ARCHITECTURAL REVIEW & APPROVAL

Project name: CORNERBROOK
 Municipality: WHITBY, ON.
 Project no.: 14037
 Drawing no.: BLOCK 12

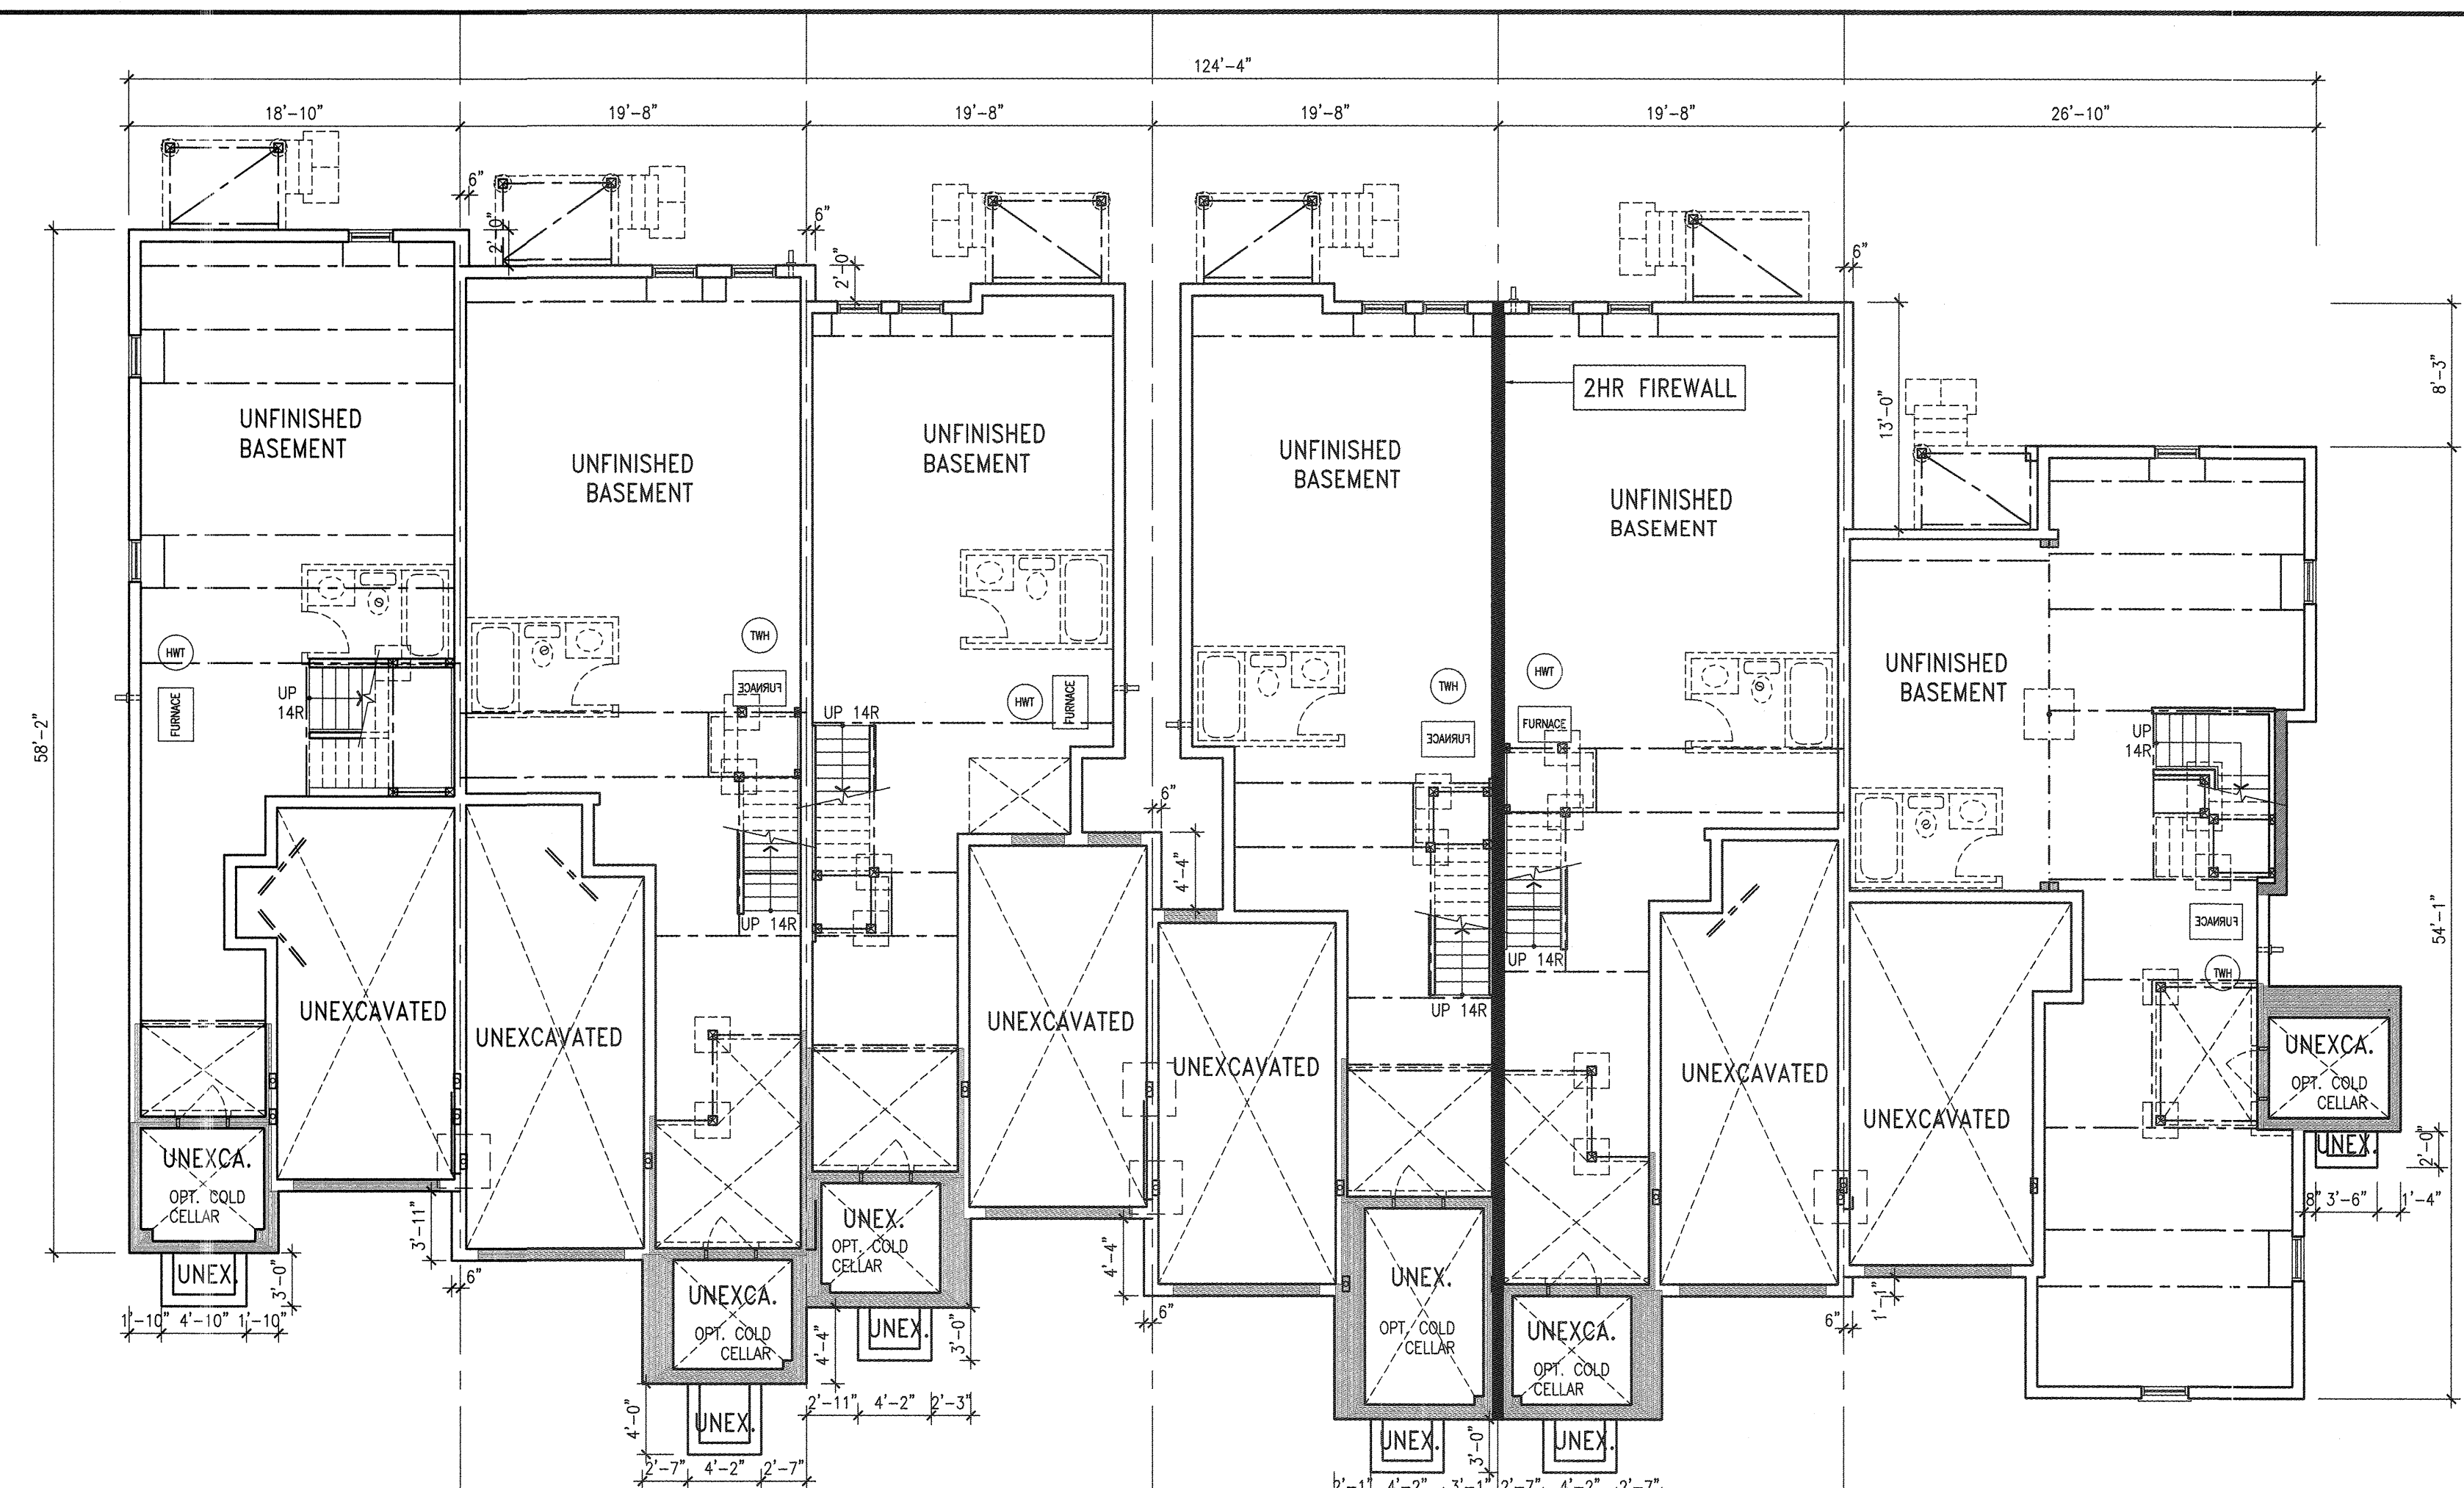
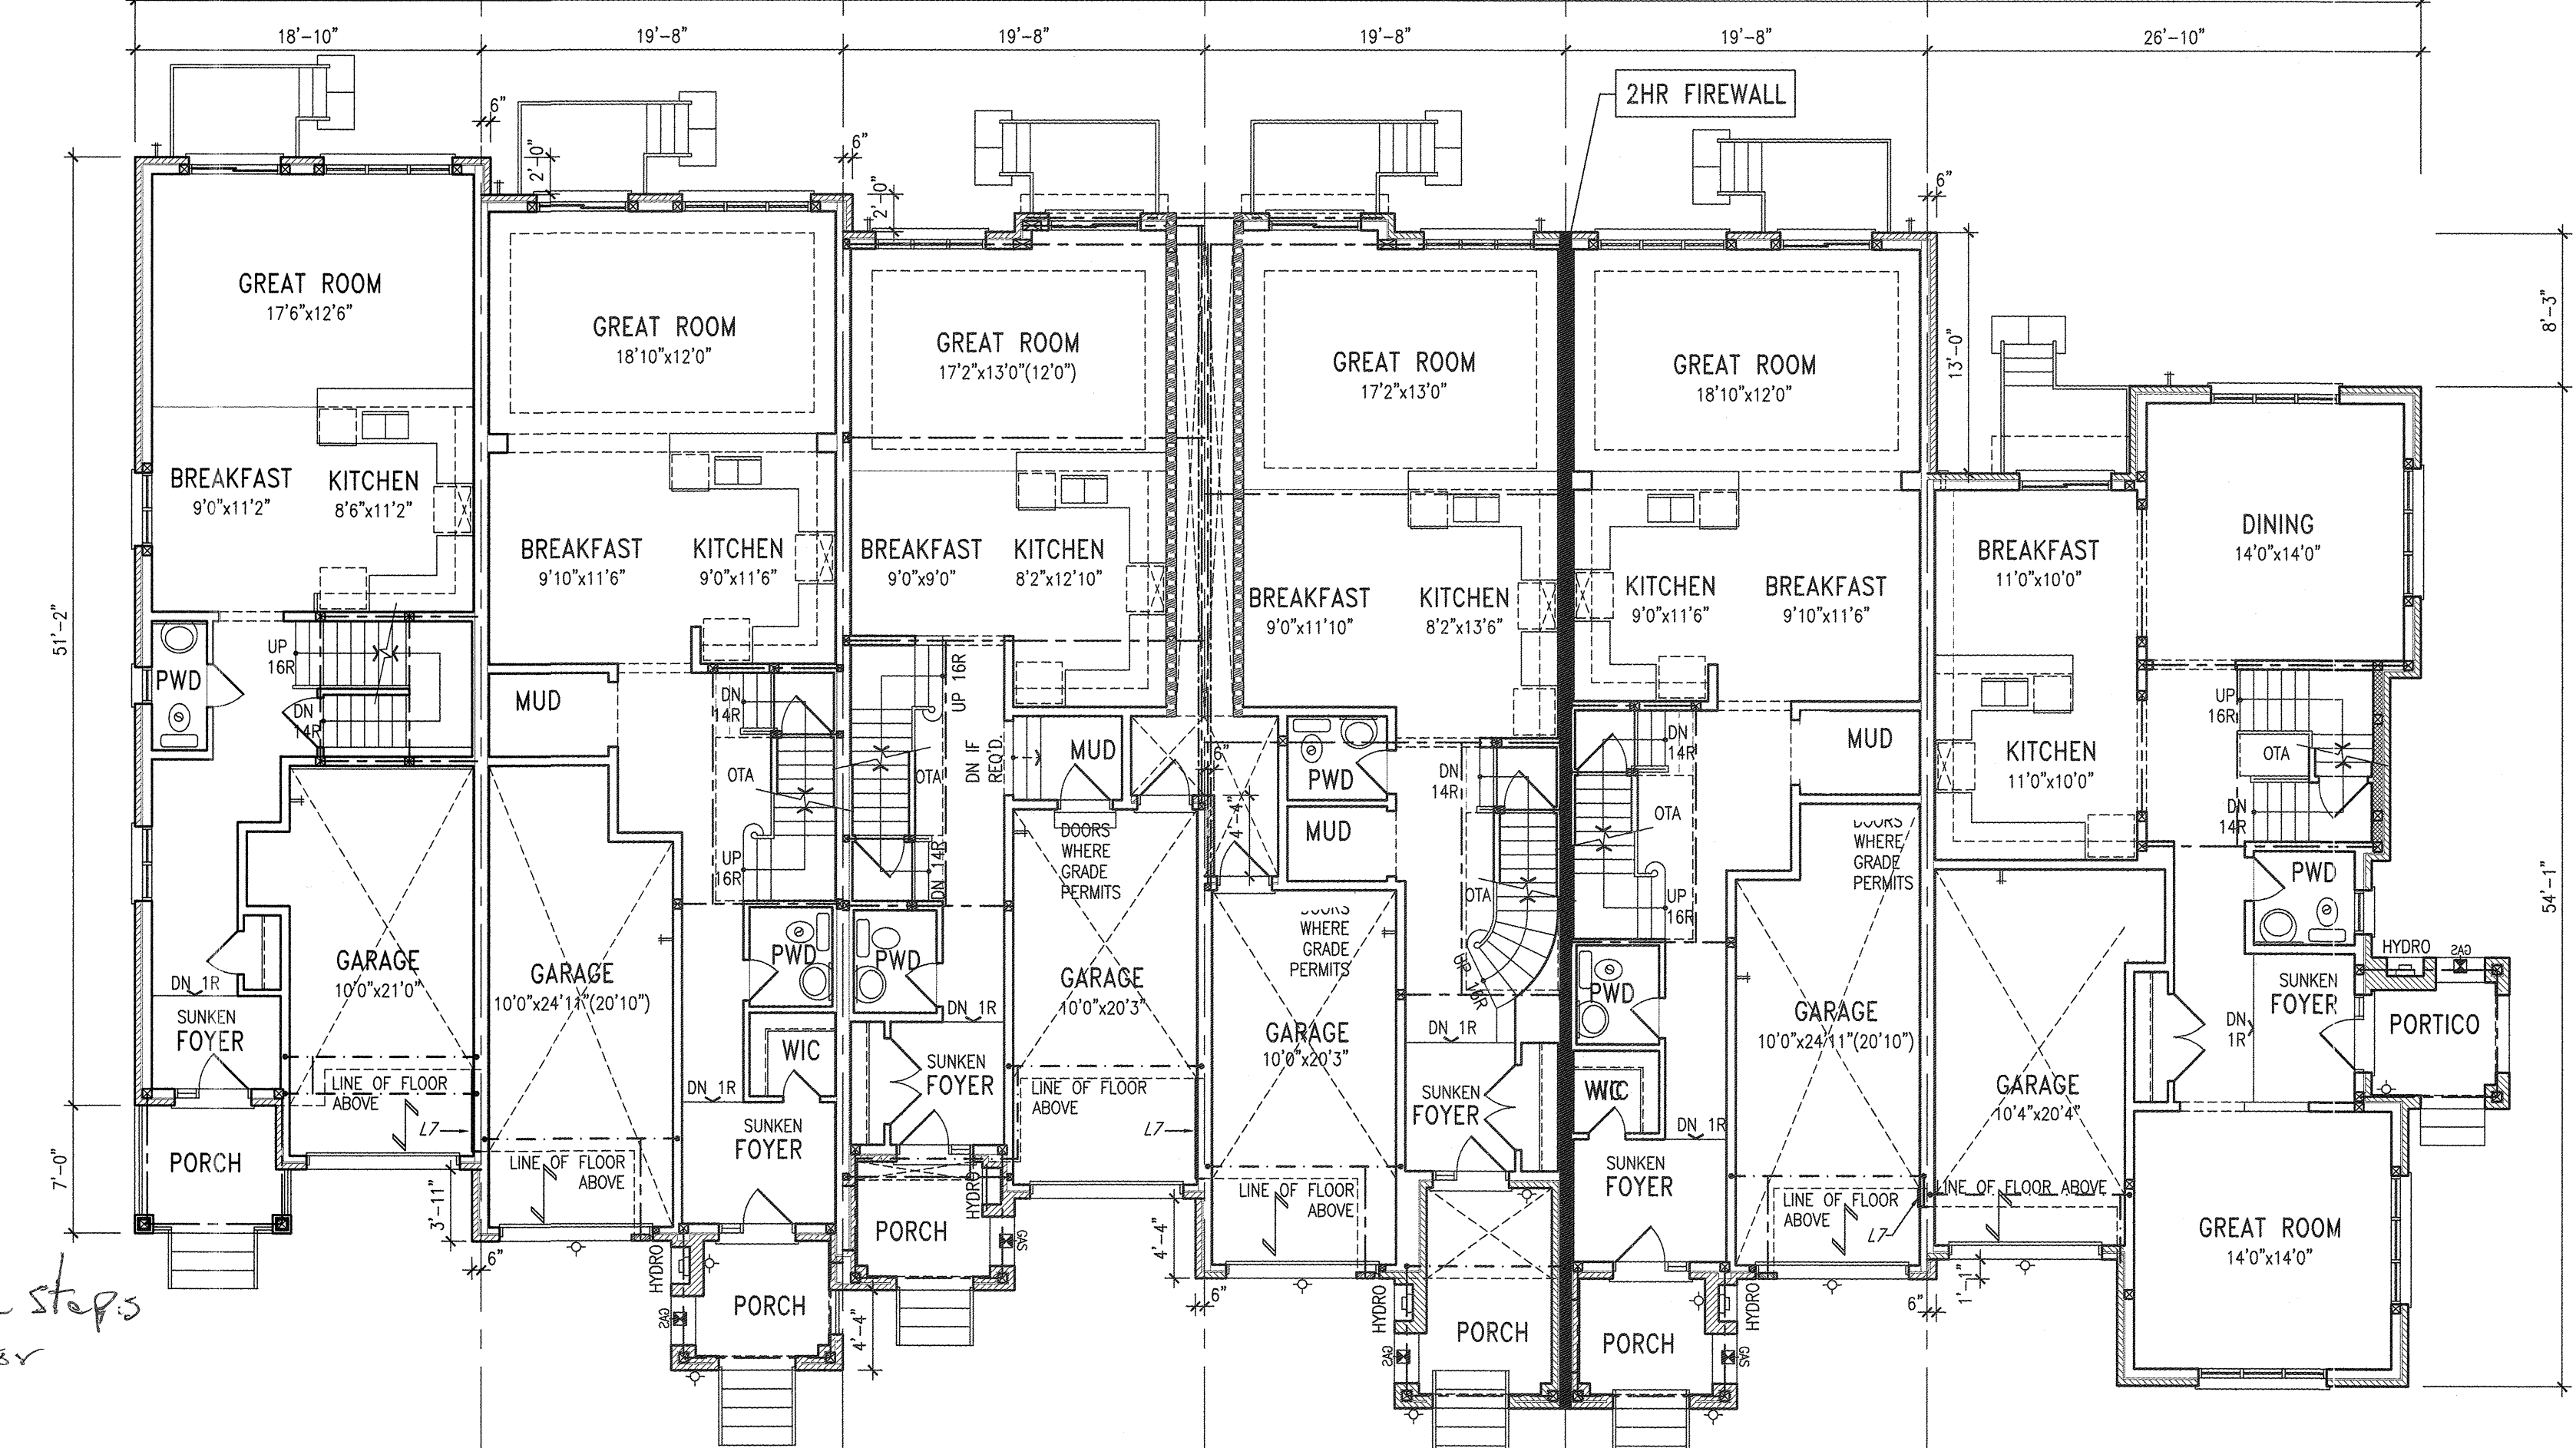
Hydro & Gas Meter recessed details are attached.

note: Poured-in-place concrete steps with stone surrounds for lots 7 to 11.
